RECORD OF DECISION

Former Aluminum Louvre Corporation
Operable Unit Number 01: On-Site Contamination
State Superfund Project
Old Bethpage, Nassau County
Site No. 130195
March 2013

Prepared by
Division of Environmental Remediation
New York State Department of Environmental Conservation

DATE	01-09-2013
FIGURE	2

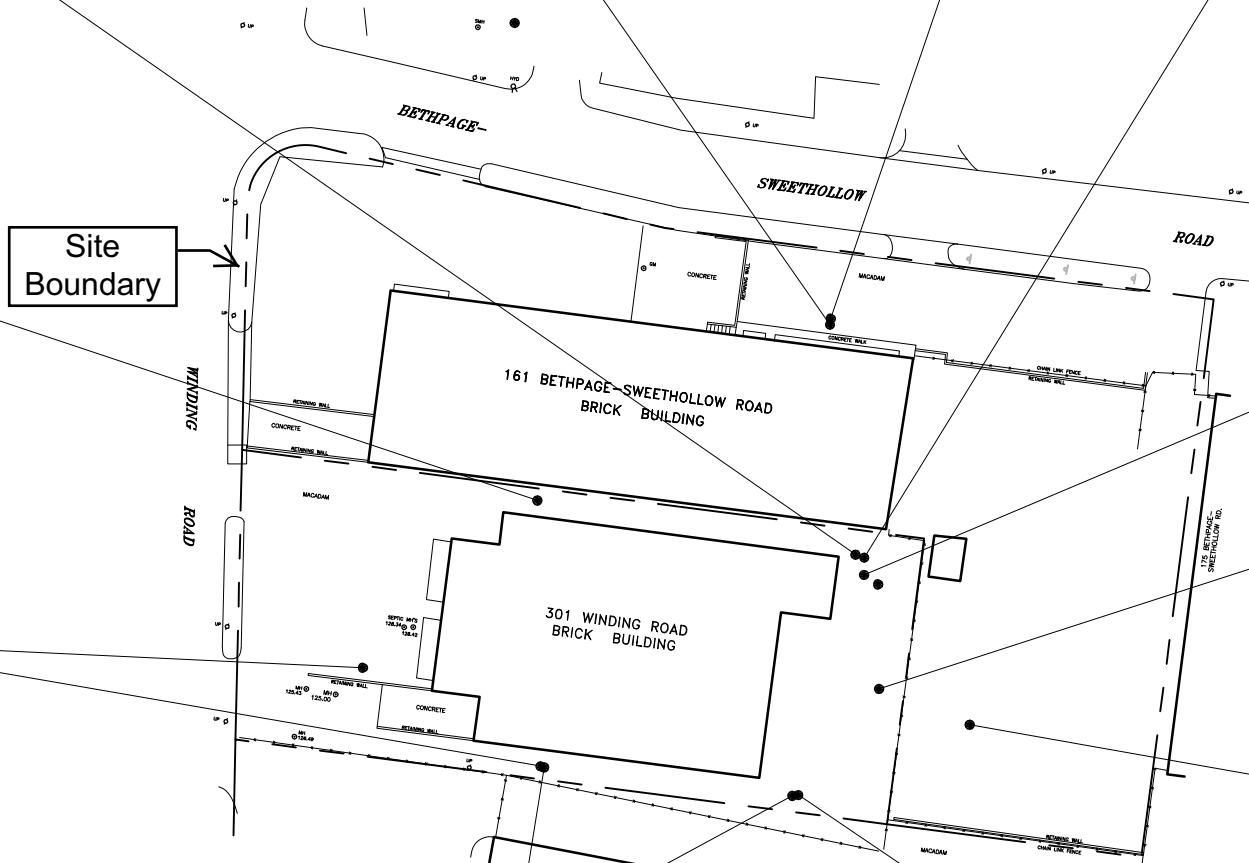
COMMENT 15: According to the PRAP, drywells appear to be the source of contaminants. What is the source of the hydraulically upgradient ground water impacts, i.e. MW-301-4, ALC-OLD-MW-2 and MW-161-1-I-2?

RESPONSE 15: Of the monitoring wells listed in the comment, all of the wells are on-site and within the OU1 groundwater regime. Of these, only MW-161-1-I is hydraulically upgradient of the known source area. To determine whether the groundwater contamination detected in MW-161-1-I originated at an upgradient source, nine groundwater samples were obtained at three locations that are off-site and upgradient of MW-161-1-I. TCE was detected in one of the nine samples at 6 ppb, exceeding the SCG of 5 ppb. As no other contaminants exceeded SCGs in the nine upgradient samples, the RI found no evidence of an upgradient source. As no on-site or off-site source of the groundwater contamination in MW-161-1-I was found during the RI, the source of the contamination in that well is unknown. In addition, the Department investigated properties north of the site during the site characterization of the Old Bethpage Industrial Area and did not find any sources upgradient of the Former Aluminum Louvre on-site contamination. Therefore, this factor was not considered when selecting the remedial action objectives identified in the PRAP and ROD.
